Requests for Waivers of Street Right-of-Way Dimensional and Sidewalk Standards & Request for Approval of Half-Street

London Towne Subdivision (Preliminary Plat)

Planning Commission Meeting
January 9, 2019

Waiver Requests

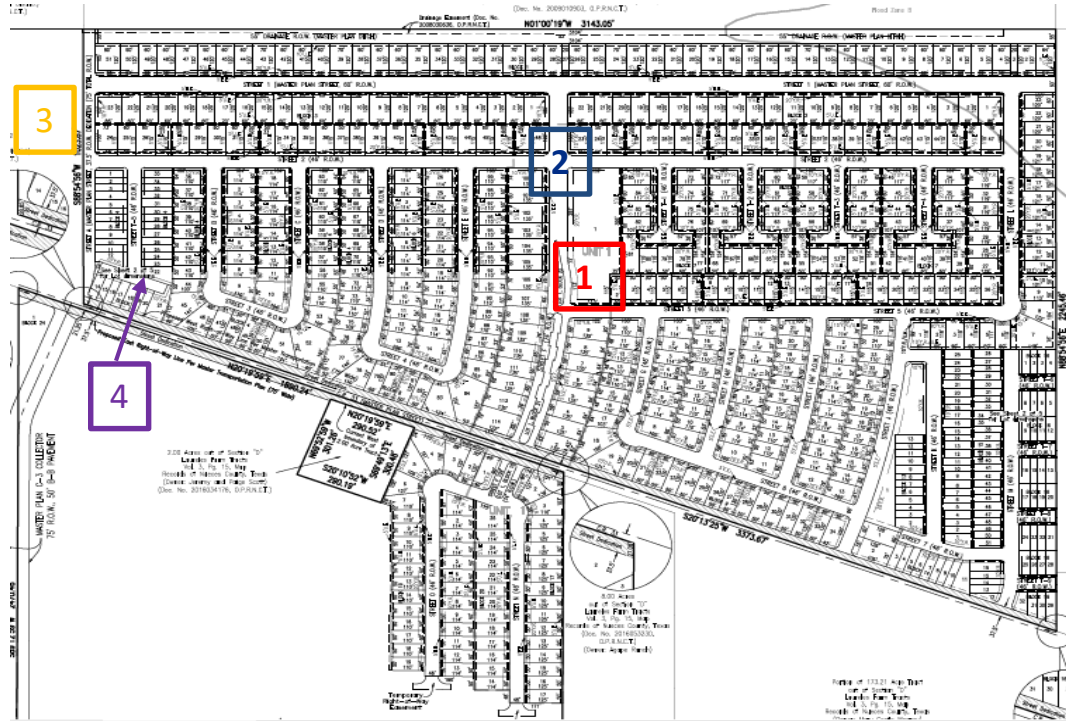
- 1. Street F: 74' ROW
- 2. Street F: 60' ROW
- 3. Street A: 75' ROW
- 4. T-5 Hammerhead
